**TOWN OF PORTOLA VALLEY
ARCHITECTURAL AND SITE CONTROL COMMISSION (ASCC)
Monday, February 10, 2014
Special Field Meetings (time and place as listed herein)
7:30 PM – Regular ASCC Meeting
Historic Schoolhouse
765 Portola Road, Portola Valley, CA 94028**

TO: ASCC
FROM: Tom Vlastic, Town Planner
DATE: February 7, 2014
RE: Agenda for February 10, 2014 ASCC Meeting

SUBJECT: ASCC & Neighbor Comments dated 01.13.14 & Responses/Drawing Revisions

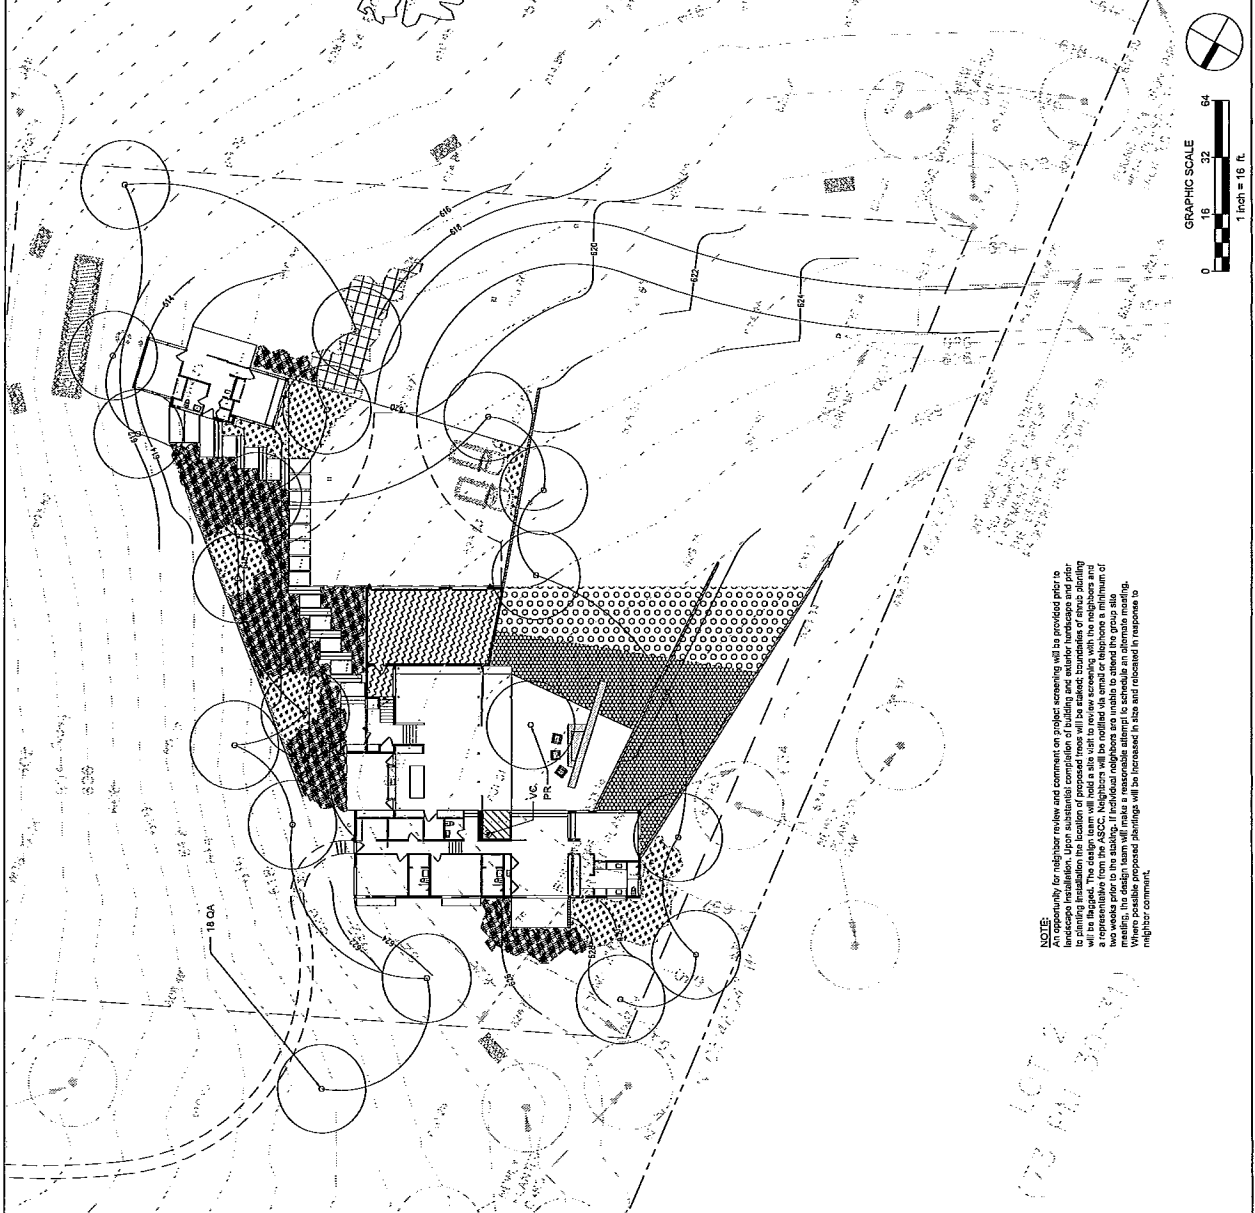
2. **Revised landscape plans.** The landscape plans have been modified to respond to neighbor concerns regarding potential visual impacts of vehicle headlights entering the site and views of the auto court and bedrooms while maintaining the visual character of the existing oak savanna. A total of 18 15-gallon live oaks, which is three more than originally proposed, are proposed to be irregularly spaced around the house and guest house so as to blend with the site and obscure views to the structures and driveway. The 15-gallon size was selected in response to

Conservation Committee and ASCC commissioner comments that smaller specimens typically grow faster than larger boxed trees. Neighbors to the east and north have expressed concerns that the smaller trees will not produce effective screening, and the ASCC will need to consider this with the revised plans. Additionally, the project team has included a proposed condition that is noted on the planting plan, Sheet L5.1, calling for field placement of the proposed oaks with the neighbors and a designated ASCC member. The location of the proposed trees would be staked and shrub planting boundaries flagged upon substantial completion of the buildings and hardscape. Neighbors would be notified at least two weeks prior to the staking, and a date for the site visit would be coordinated with neighbors and planning staff. Staff suggests that a construction schedule be submitted by the general contractor prior to building permit issuance that includes the timing of the screen planting field placement meeting.

Revised Sheet: L5.1

- *3 trees have been added to the plans to provide additional screening and dispel a bunched affect*
 - *The X that designated trees as potential removals from plans have been removed*

SHEET TITLE
**EXTERIOR
 ELEVATIONS**

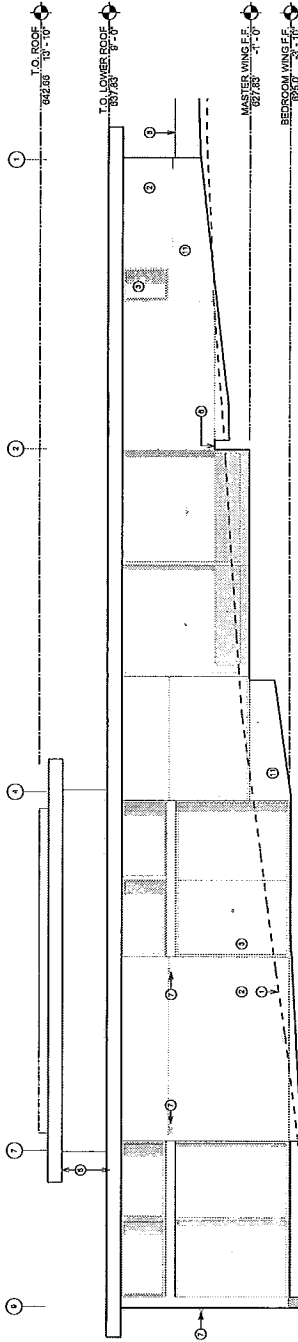
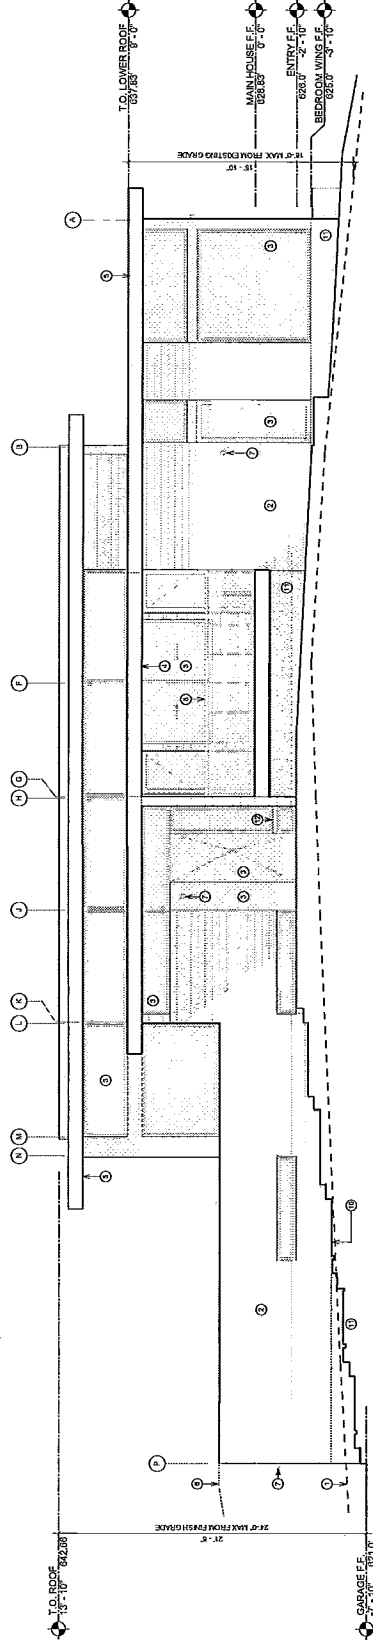
5. (MK) asked if there will be any architectural light outside the (2) northeast bedrooms.
ACTION: (FA) added (2) sconces between the (2) glass sliding doors between bedroom 1 & bedroom 2 at the Main House. The sconce spec. shall be the same as noted on sheet A1.01.

Revised Sheets: A1.01 & A3.01

PROPOSED SITE LIGHTING
 SCALE: 1" = 30'

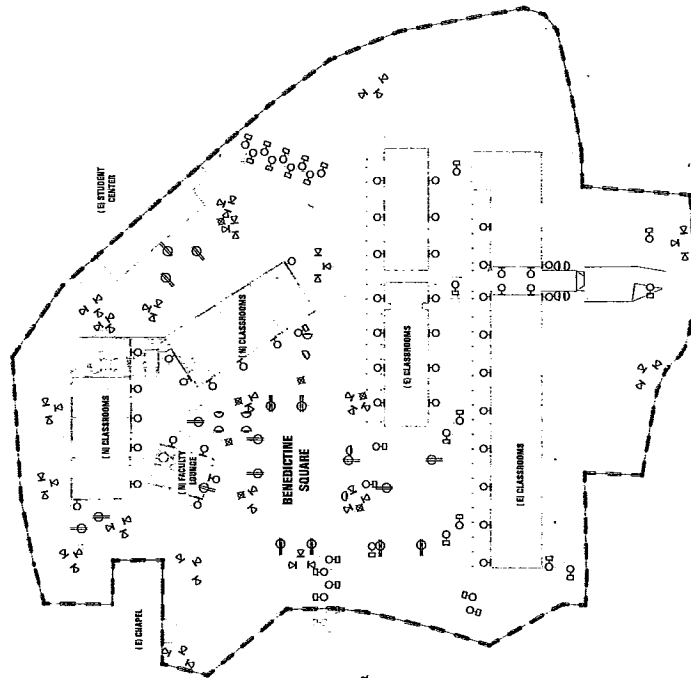
7. **Proposed lighting plan.** The proposed lighting plan, as shown on Sheet A1.2, includes lighting for the new buildings, both Benedicene and Church Squares, and the existing buildings adjacent to the Squares. Existing fixtures in these areas would be removed and replaced in order to provide for a consistent and cohesive lighting arrangement.

All of the proposed fixtures are downlights, and the lighting designs as shown on Sheet A1.2 and the provided cut sheets are generally consistent with the Town's standards. The project team has been asked to provide information about the brightness that is being proposed, as some fixtures are described with a range of illumination.

In order to better judge the lighting, the ASCC may want to request that the lighting plan be shown relative to a more detailed site plan, such as perhaps a grayed out version of the landscape site plan. That would allow the ASCC to see the light locations in relation to doors, planters, retaining walls, staircases and similar features. This would also help to ensure that the lighting plan is complete. Currently, for example, Sheet A1.2 does not show the proposed new pathway from the new buildings to the north end of the deck behind the Student Center, which raises the question of whether some path or step lighting will be needed in that location.
